HISTORIC AND DESIGN REVIEW COMMISSION

December 20, 2017

HDRC CASE NO: 2017-623
ADDRESS: 925 LAMAR ST
LEGAL DESCRIPTION: NCB 1369 BLK 6 LOT S 135 FT OF 16 & W 4.6 OF S 135 FT OF 17
ZONING: R-4, H
CITY COUNCIL DIST.: 2
DISTRICT: Dignowity Hill Historic District
APPLICANT: FDN Home, LLC
OWNER: DiaLuz Realty LLC
TYPE OF WORK: Rear Addition
APPLICATION RECEIVED: December 01, 2017
60-DAY REVIEW: January 30, 2017

The applicant is requesting a Certificate of Appropriateness for approval to construct a rear addition to feature approximately 300 square feet.

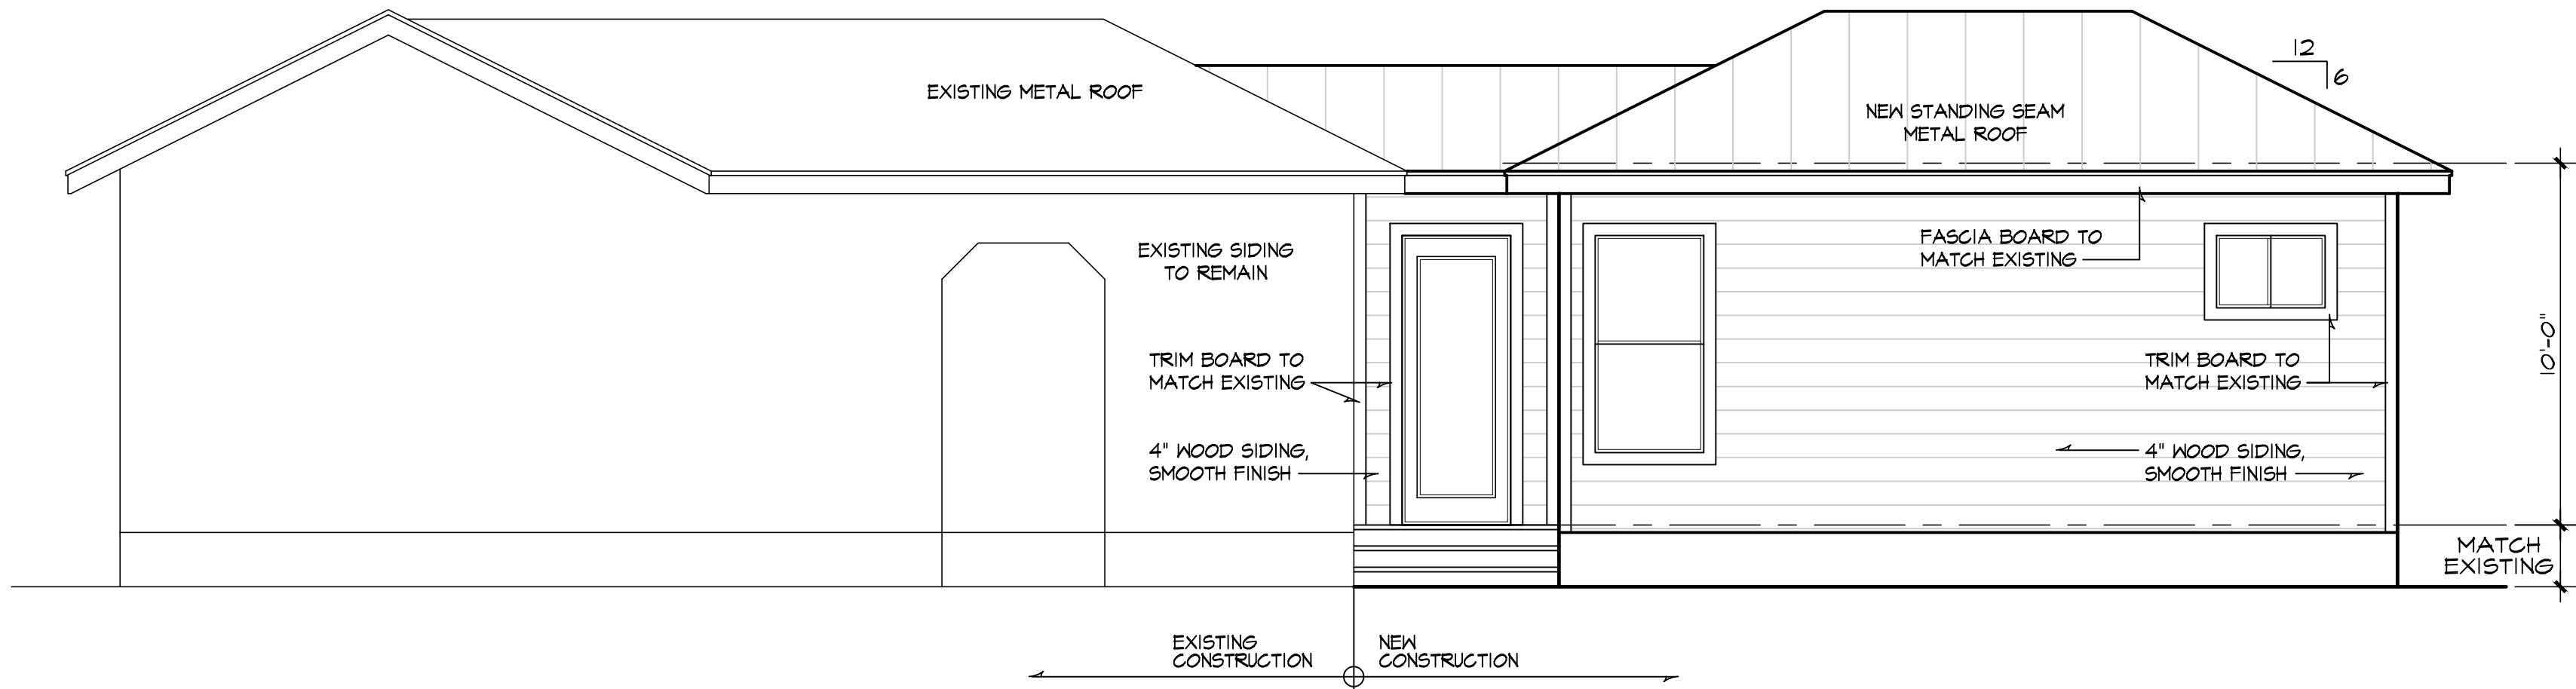
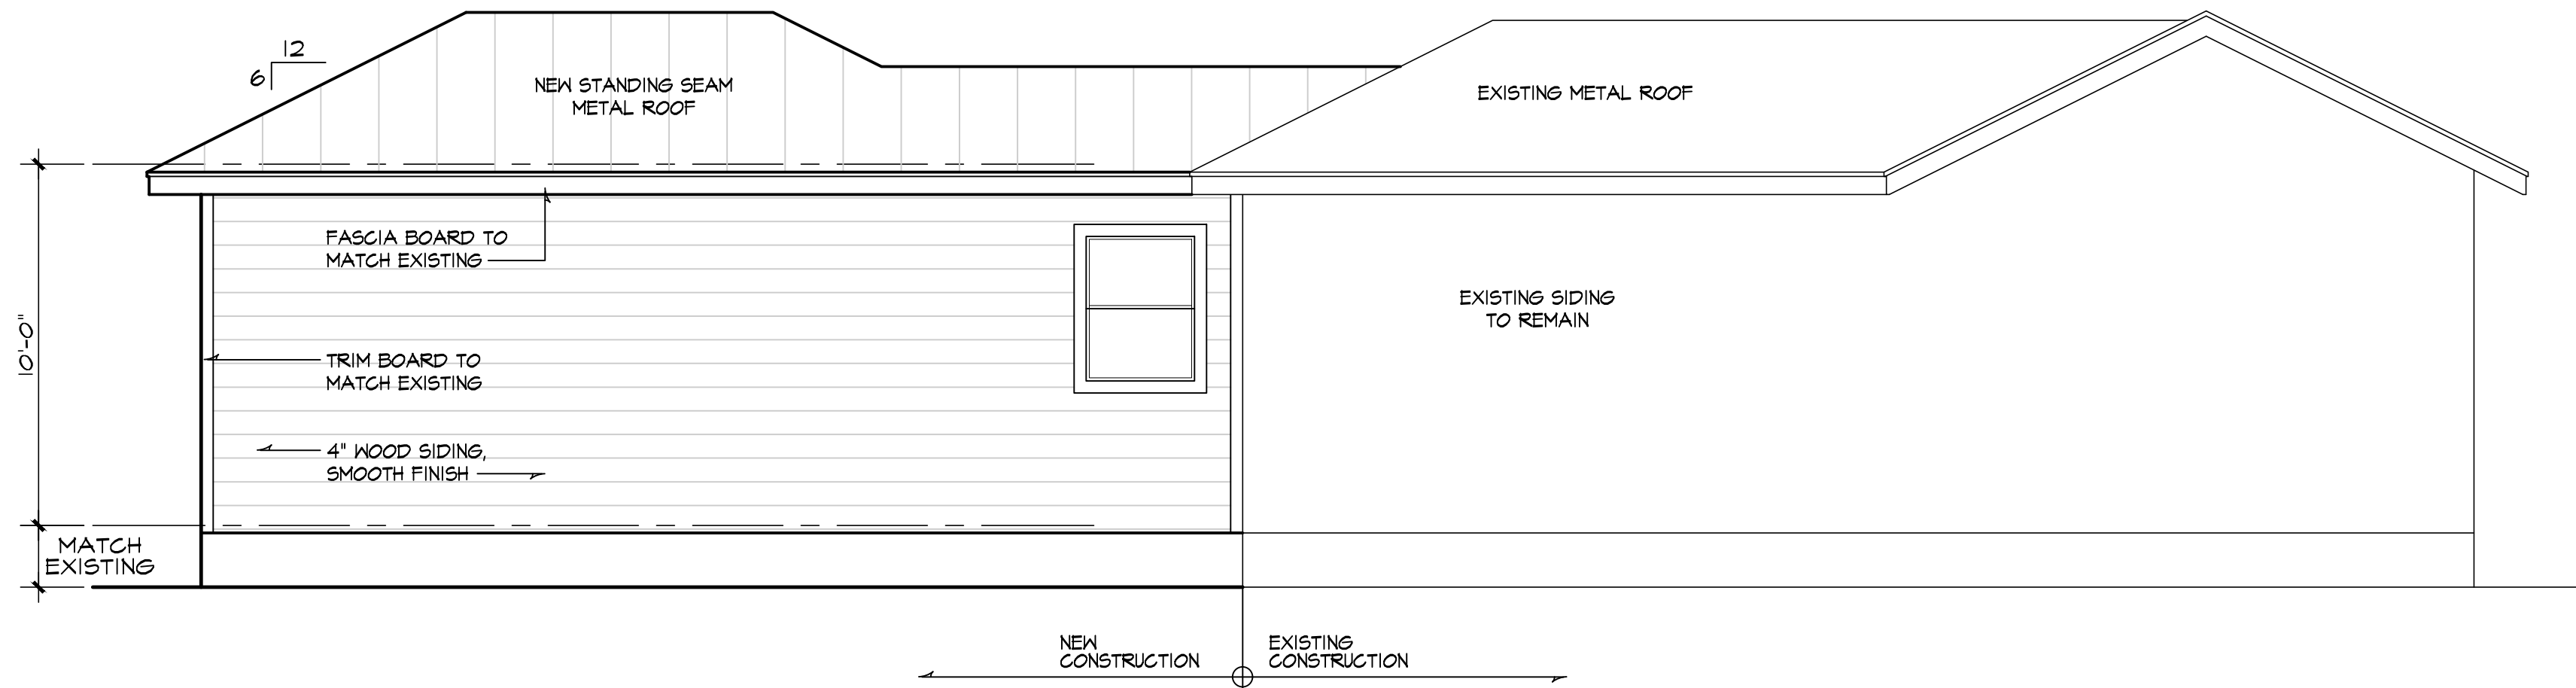
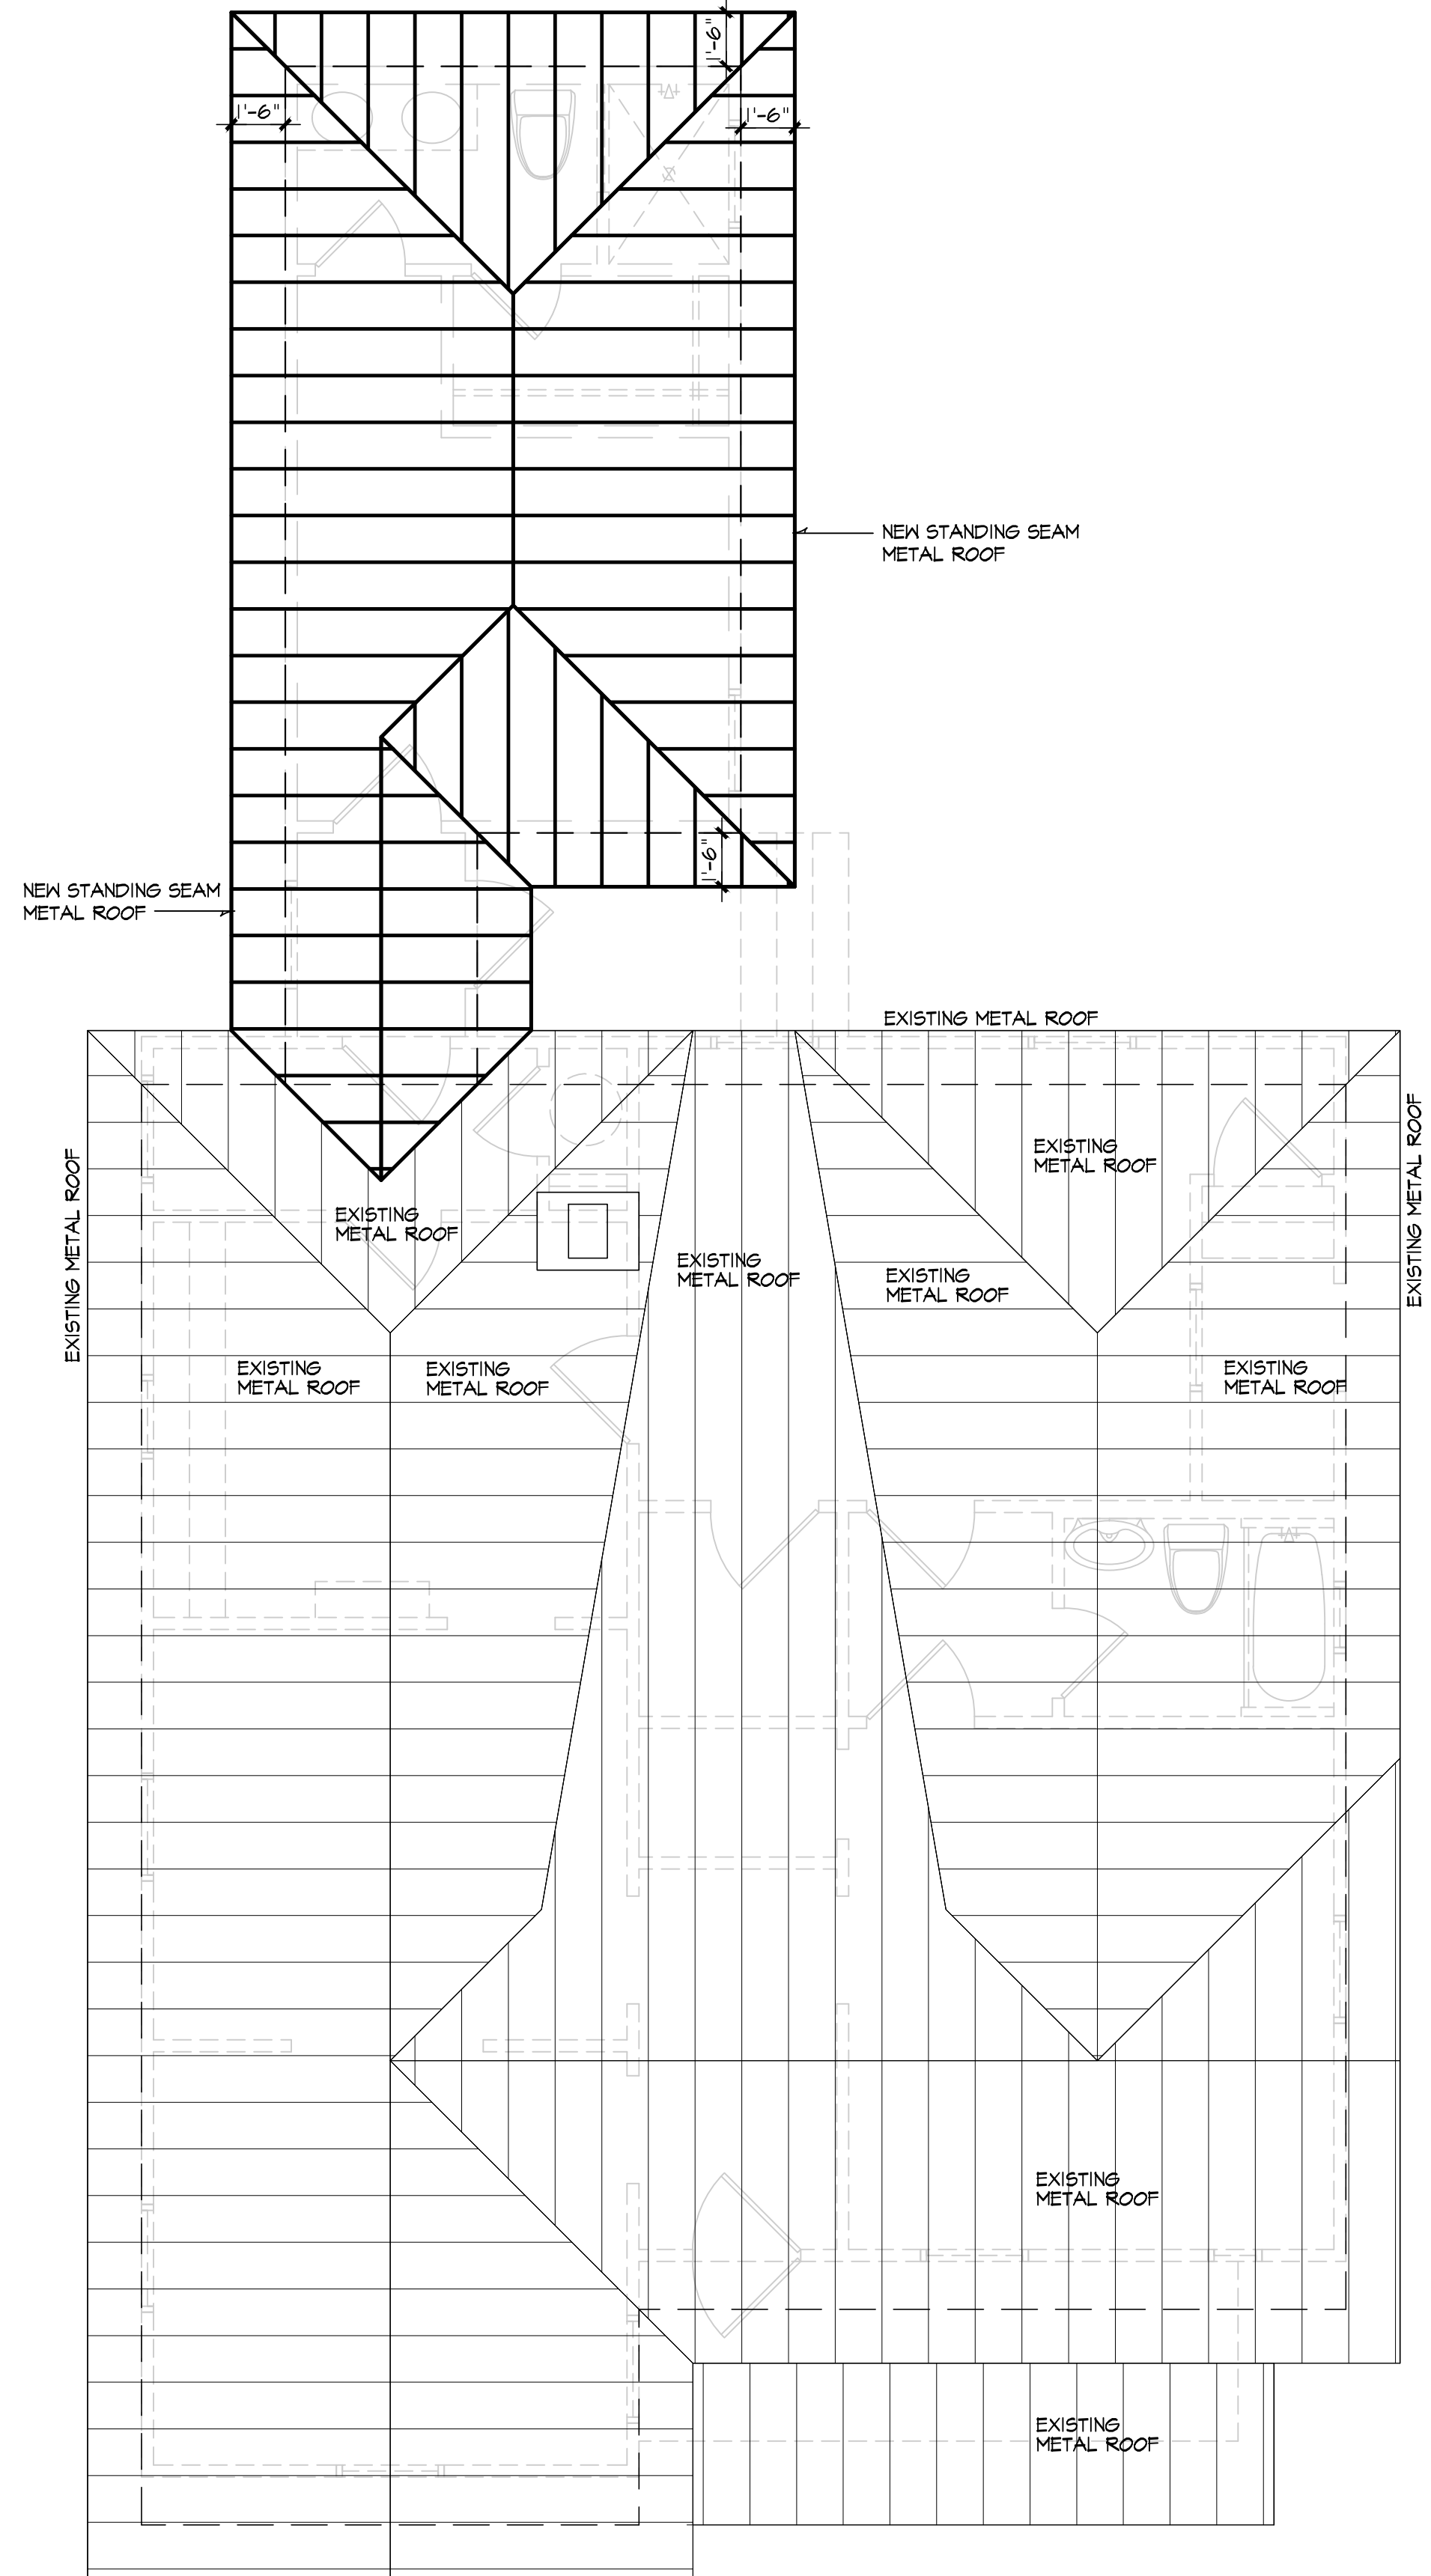
- b. REAR ADDITION – The Guidelines for Additions 1.A. states that additions should be sited to minimize visual impact from the public right of way, should be designed to be in keeping with the historic context of the block, should utilize a similar roof form and should feature a transition between the old and the new. The applicant has proposed for the rear addition to feature a hipped roof that is to feature a ridgeline that per the construction documents is slightly greater than that of the primary historic structure. For a rear transition, the applicant has proposed for the width of the proposed addition to be subordinate to that of the historic structure and has proposed to construct the majority of the addition’s massing separate from the massing of the historic structure. Staff finds that the addition should feature a roofline that is subordinate to that of the primary historic structure.

- e. MATERIALS – Regarding materials, the proposed standing seam metal roof should feature panels that are 18 to 21 inches wide, seams that are 1 to 2 inches in height, a crimped ridge seam and a standard galvalume finish. A large ridge cap should not be used. Regarding windows, the applicant has proposed to install wood windows with the exception of one aluminum window in a bathroom shower. Regarding window installation, white manufacturer’s color is not allowed, and color selection must be presented to staff. There should be a minimum of two inches in depth between the front face of the window trim and the front face of the top window sash. This must be accomplished by recessing the window sufficiently within the opening or with the installation of additional window trim to add thickness. Window trim must feature traditional dimensions and an architecturally appropriate sill detail. Window track components must be painted to match the window trim or concealed by a wood window screen set within the opening. Details on each should be submitted to staff for review.

- i. That the rear addition feature an overall height that is consistent with or subordinate to that of the primary structure as noted in finding b.
- ii. That the proposed standing seam metal roof feature panels that are 18 to 21 inches wide, seams that are 1 to 2 inches tall, a crimped ridge seam and a standard galvalume finish as noted in finding e.
- iii. That the addition feature wood or a cementitious siding that features an exposure of four inches and a smooth exterior finish as noted in finding d.
- iv. That the proposed wood and aluminum windows follow specifications noted in finding e.
